STATE OF NORTH CAROLINA
DEPARTMENT OF TRANSPORTATION

Addendum No. 1
RE: Contract # C204039
WBS # 34243.3.2
STATE FUNDED
Polk County (I-4729A)
I-26/US-74/NC-108 Interchange Modifications in the Town Of Columbus

September 19, 2017 Letting

The following revisions have been made to the Roadway plans:

0 5 10
PROJ. REFERENCE NO.
I-4729A
SHEET NO.
X-71
6/23/16
29+00.00
28+50.00
28+00.00
0.064
0.060
0.060
1070
1060
1050
1040
-CONN_B_REV-
14-AUG-2017 08:20
J:\I-4729A\Roadway\XSC\I-4729A_Rdy_xpl.dgn
$$$$USERNAME$$$$

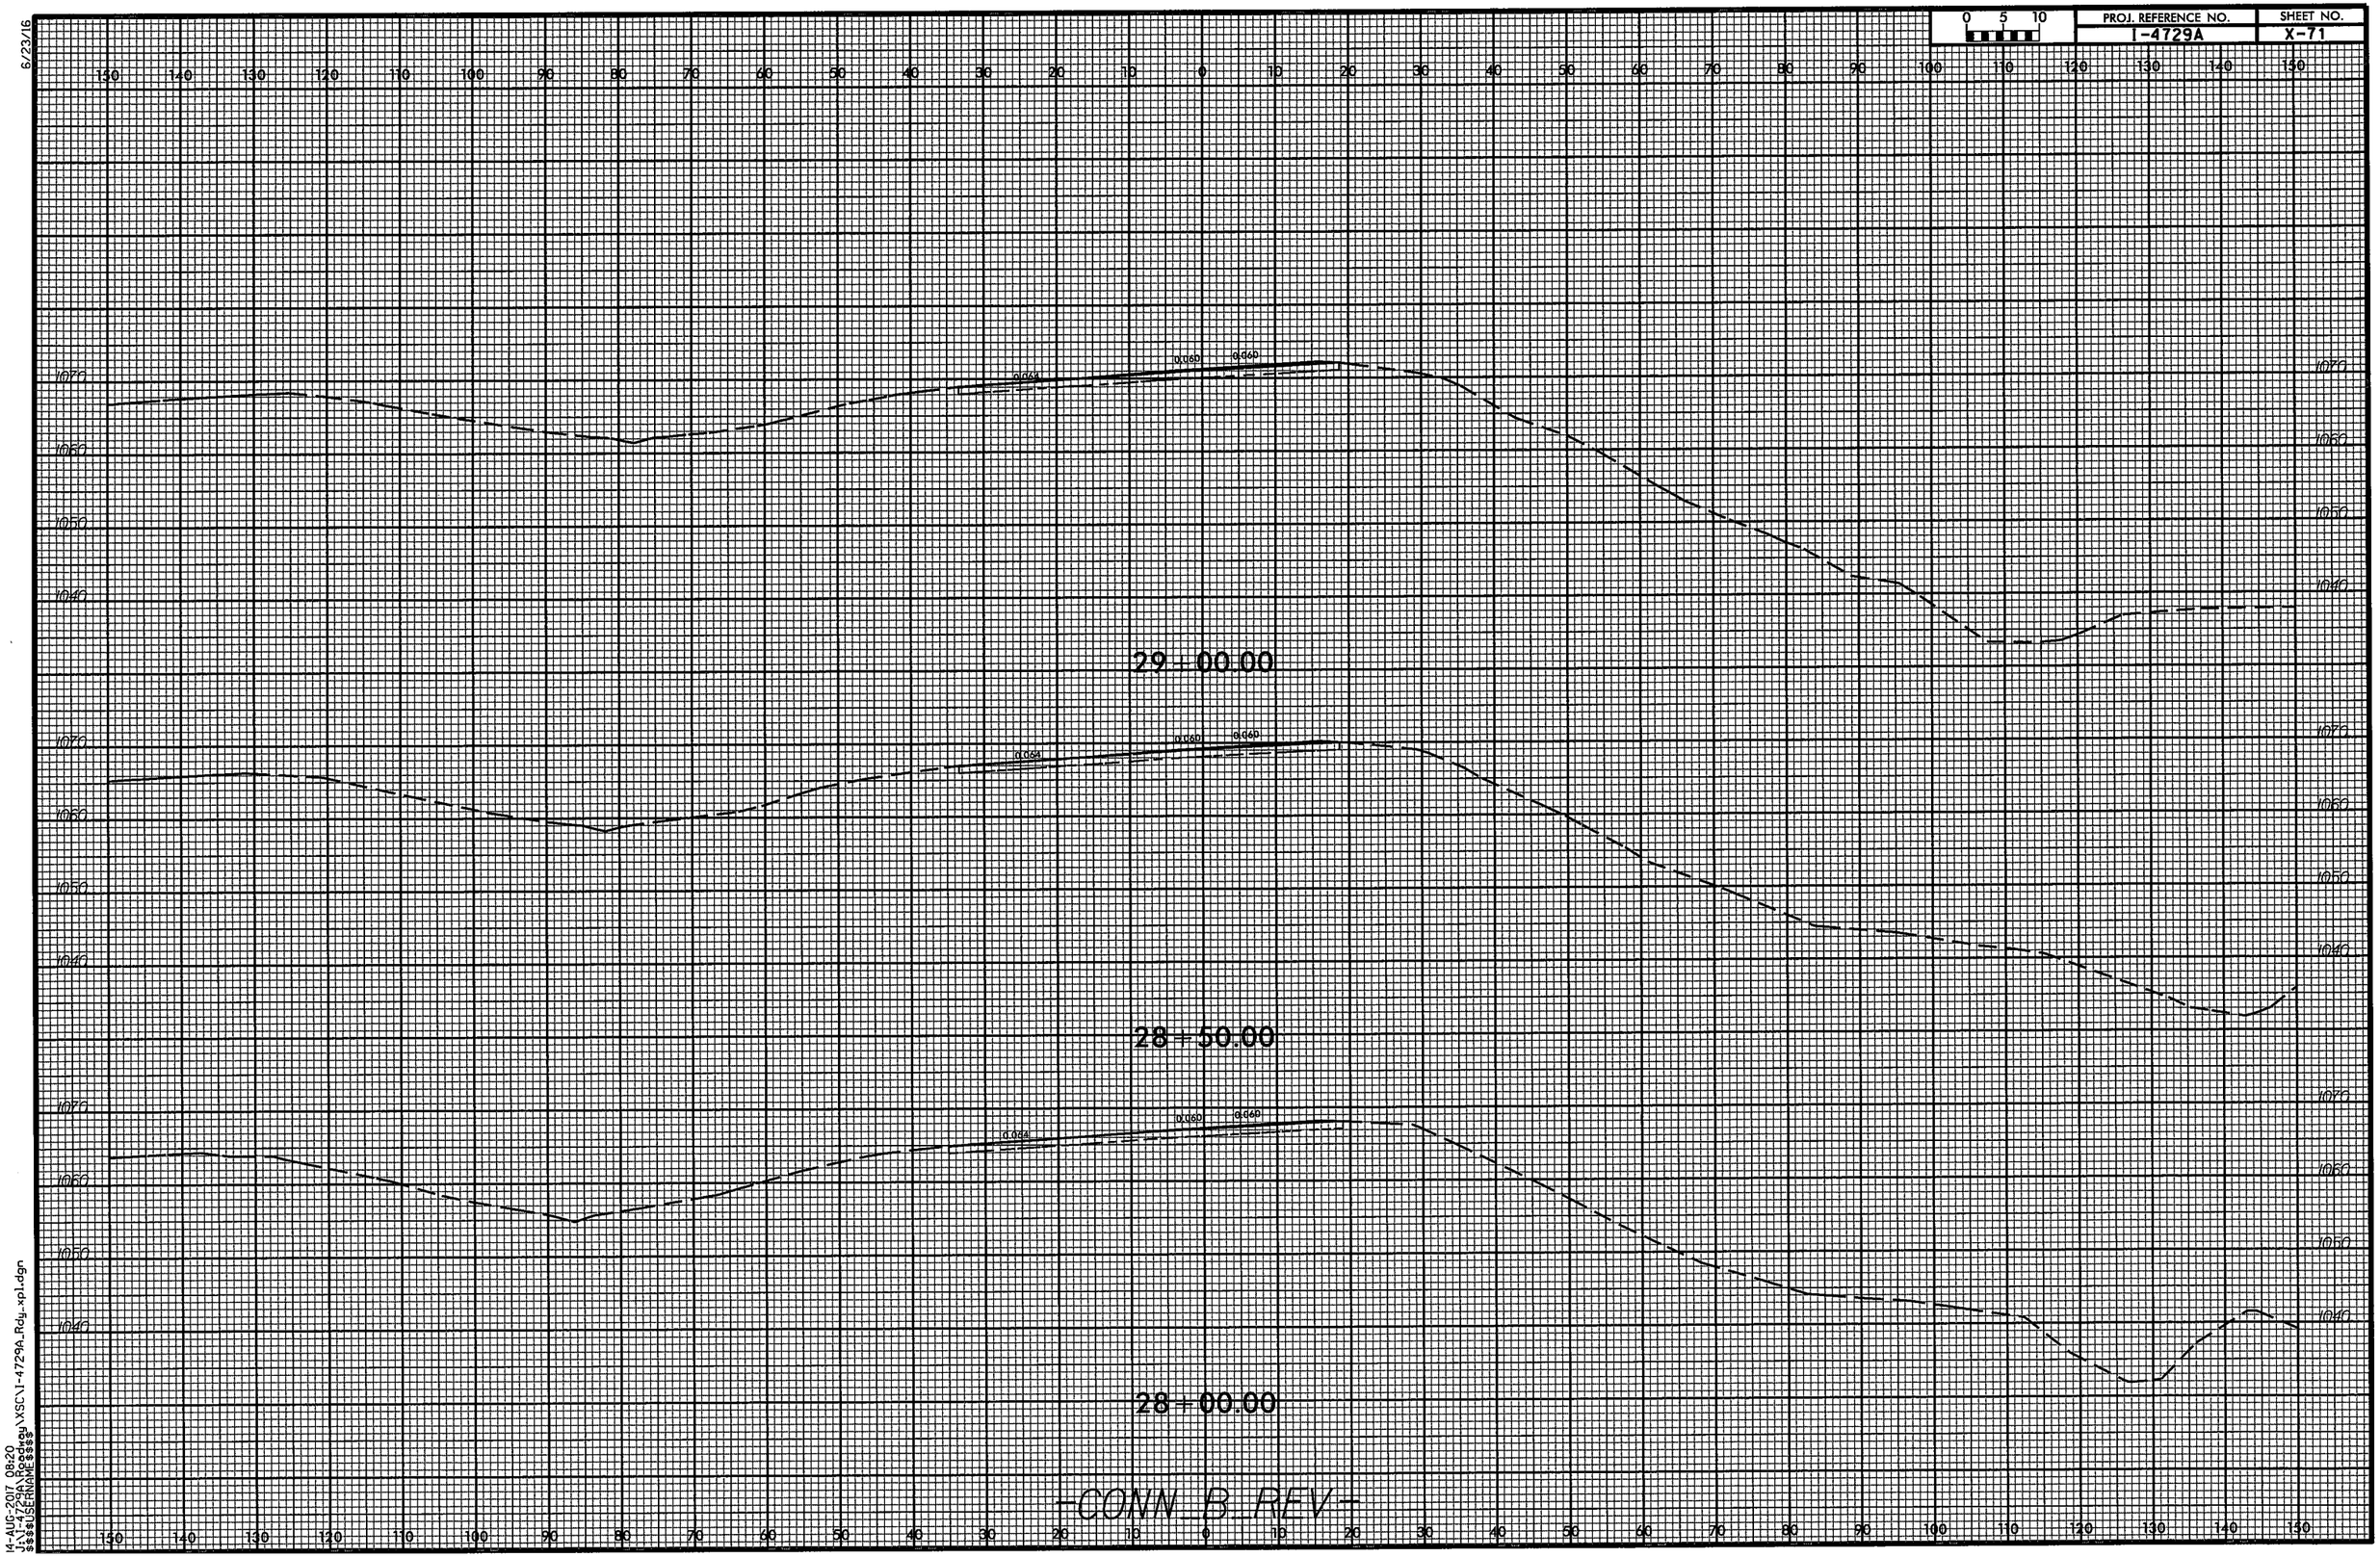
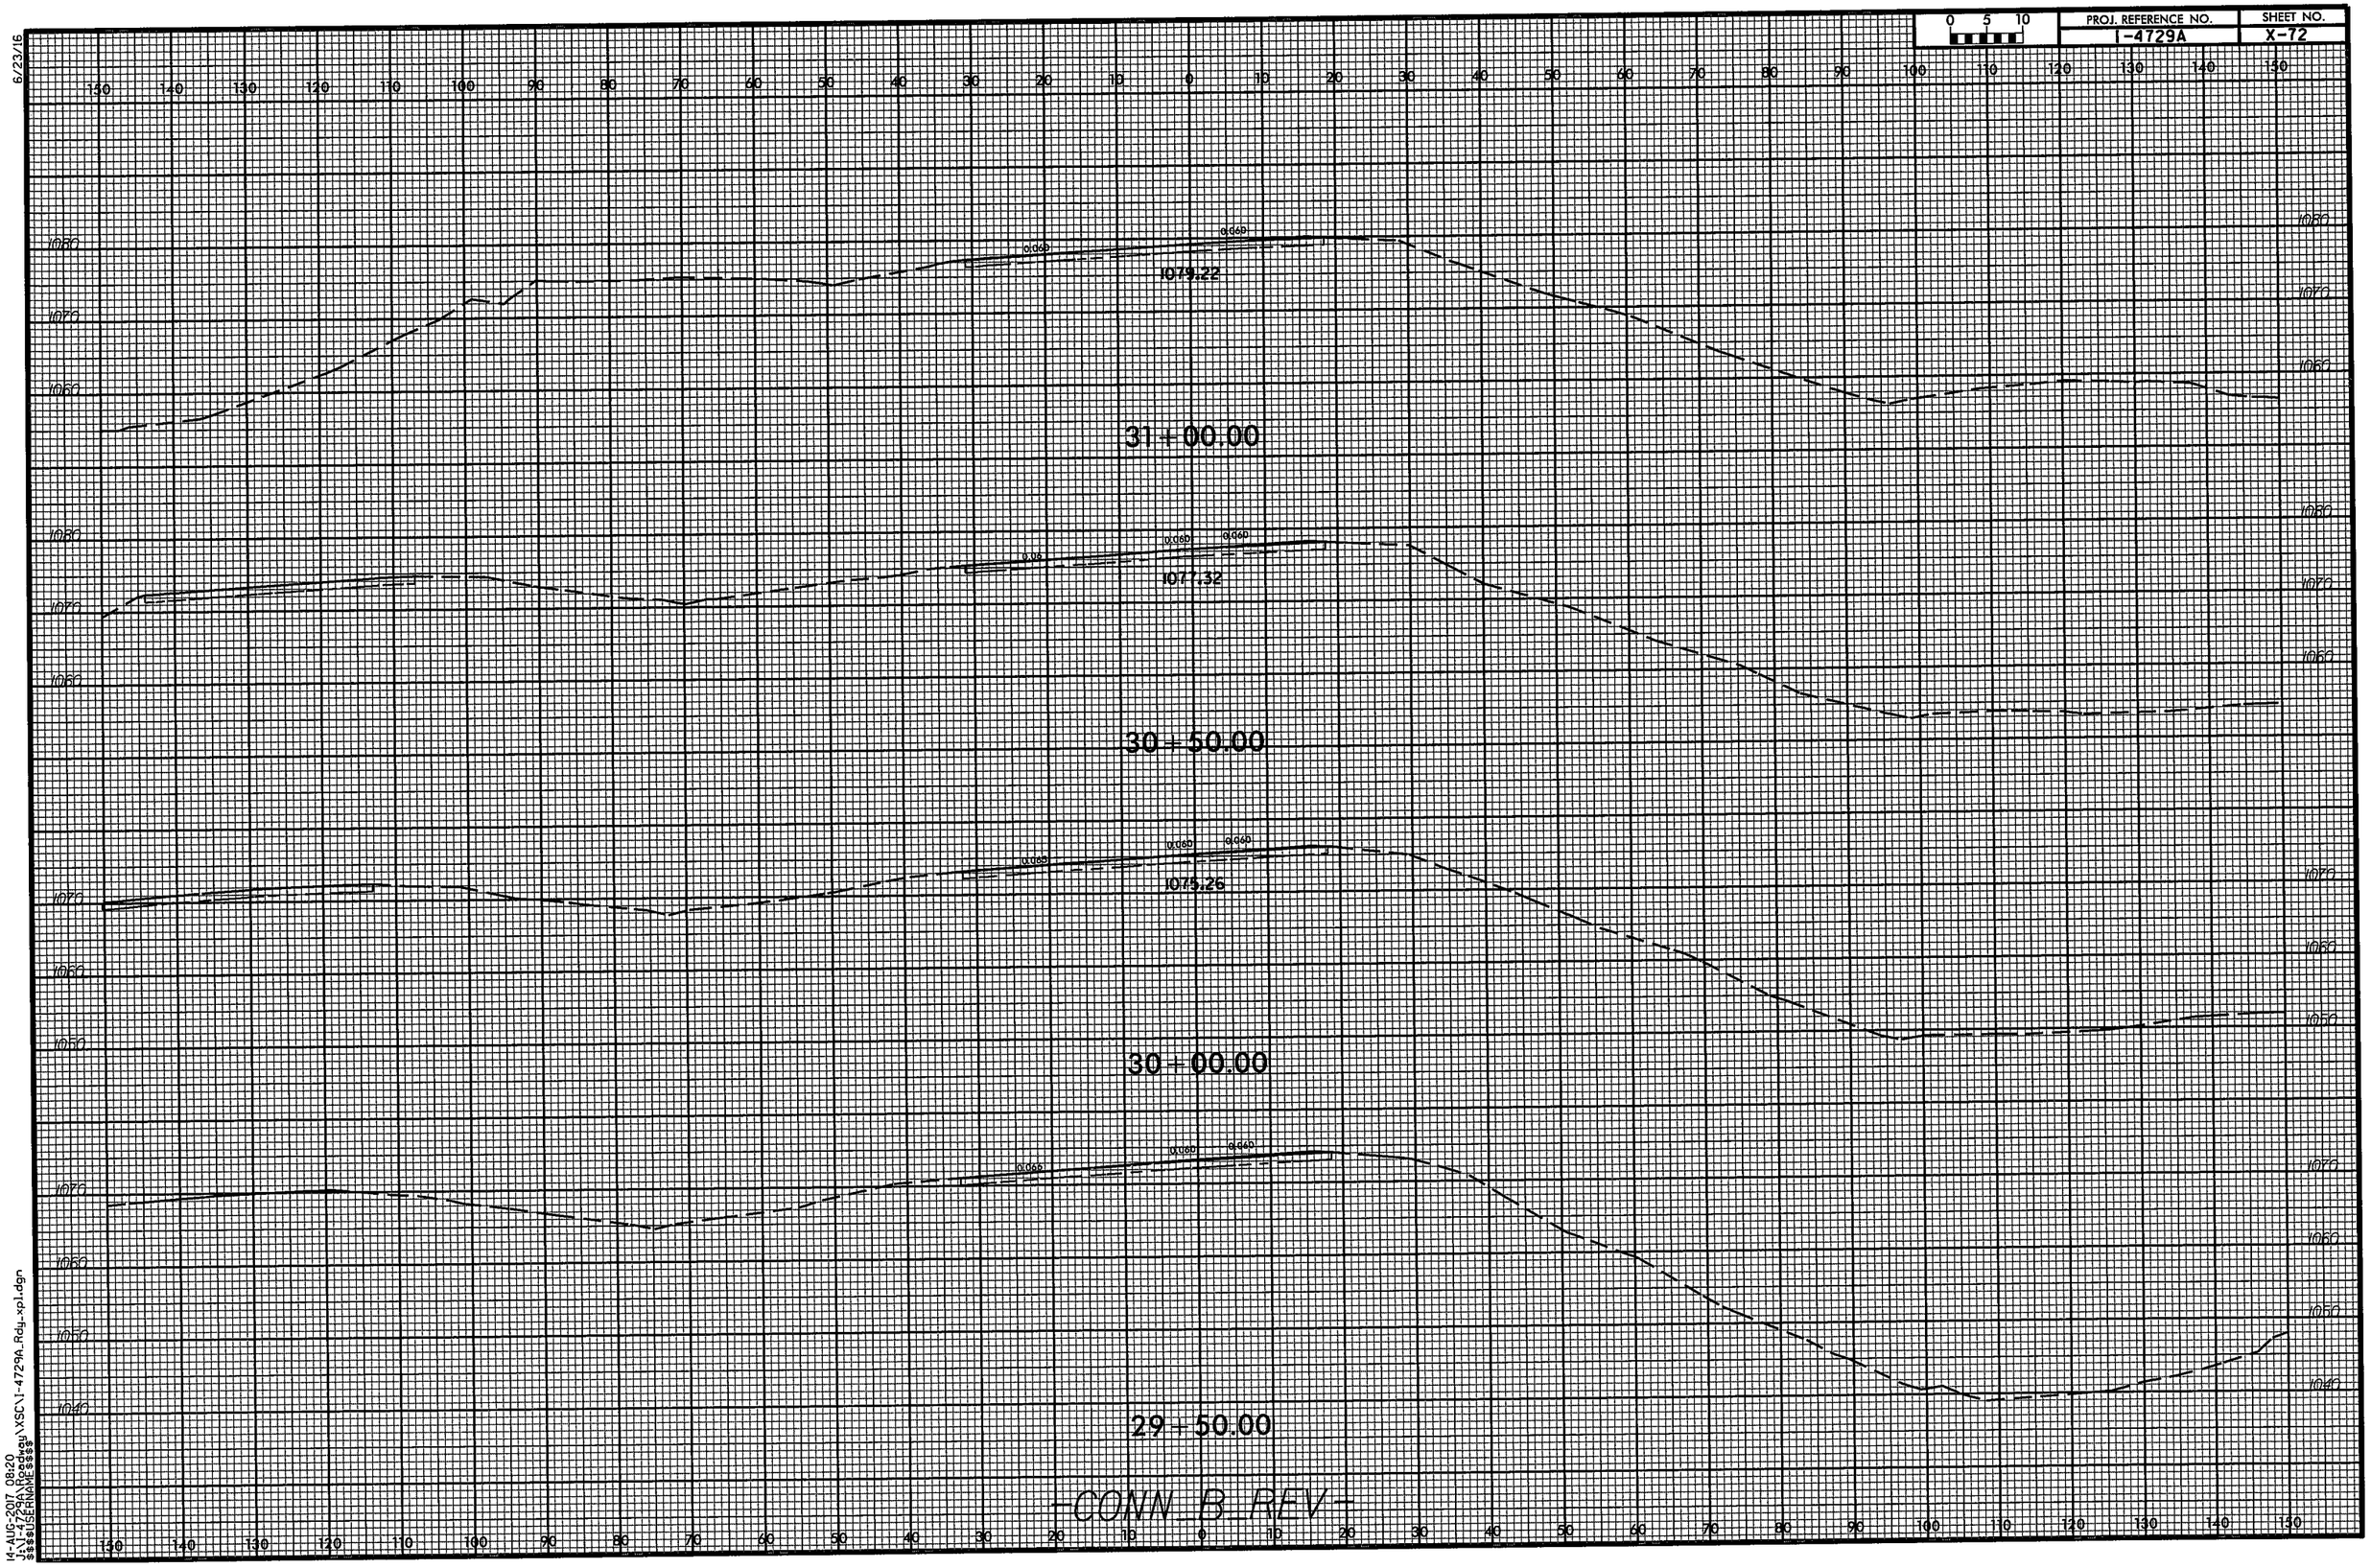
Sheet No.	Revisions
1A	Revised Index of Sheets to remove 2G-2 "Standard Embankment Monitoring Detail" and revise the number of" Drainage Summaries" sheets
2A-1, 2A-4 and 2A-5	Revised the Typical Sections for the change in mainline pavement widening design from ABC to Asphalt Base
3B-1	Revised 'Summary of Earthwork' to account for pavement widening design change
3D-1 thru 3D-4	Various drainage quantity changes as noted below
3G-1	Removed "Settlement Gauge Summary" and added note that Bridge Waiting Period only applies to Approach Slab construction
5	Revised to require Welded Steel Pipe by Trenchless method under the Interstate 26
X-1A thru X-87	Revised Cross-Sections to reflect the change in Earthwork due to the pavement design change
